# LOC2023-0212

Springbank Hill Community is unable to support this Application

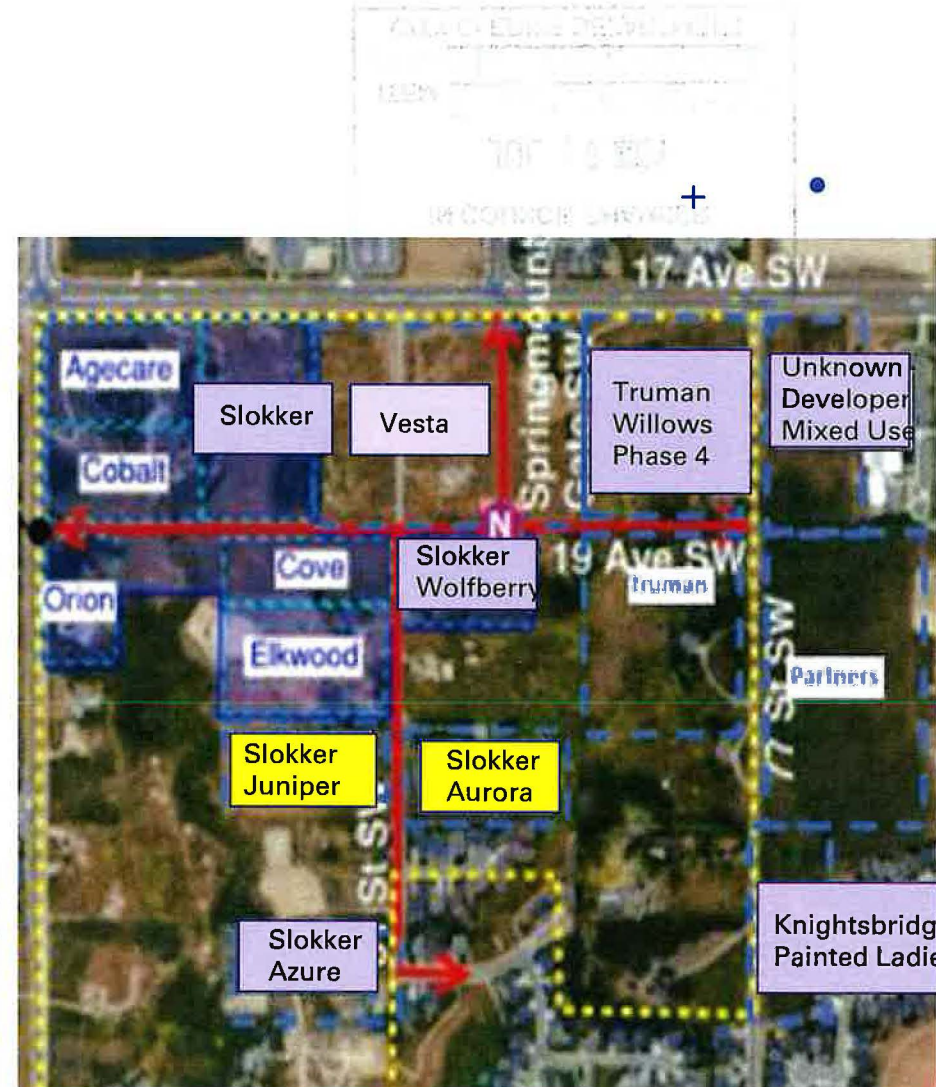
- SpringBank Hill ASP Approved 2017  
June 13 – Bylaw28P2017
- 190 Acre area was reviewed specifically to :
  - Dramatically increase density in the community to MDP standards
  - Introduce diverse buildforms in a cohesive manner with fragmented ownership in an attempt to create a comprehensive development framework

- ASP introduced several density zones, but the 3 related to LOC2023-0212 are :
  - Low Density Contextual -12- 20uph
  - Low Density 20-37 uph
  - Medium Density 38-148uph

- Change Low Density Contextual to Low Density  
37uph - 85% increase
- Change Low Density to Medium Density  
\*The developer promises to cap it at 65uph (d65)  
65uph – 76% increase

## OUTLINE PLAN STATISTICS

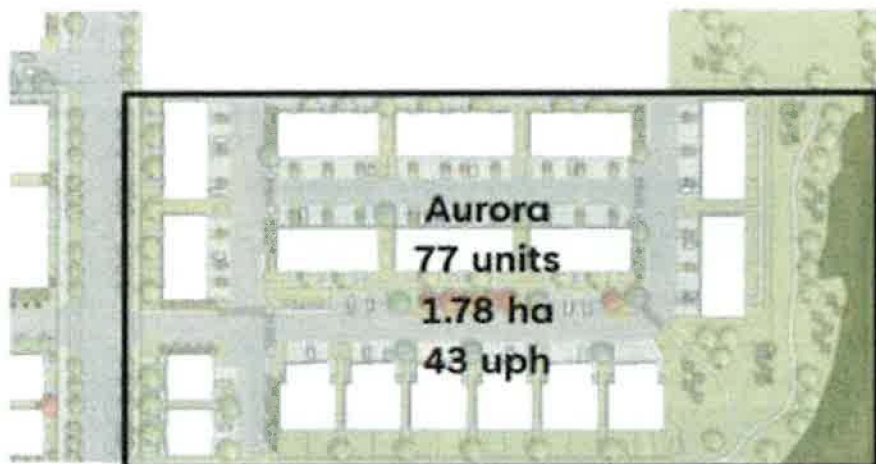
- Applicant shows densities averaged across parcels which is misleading
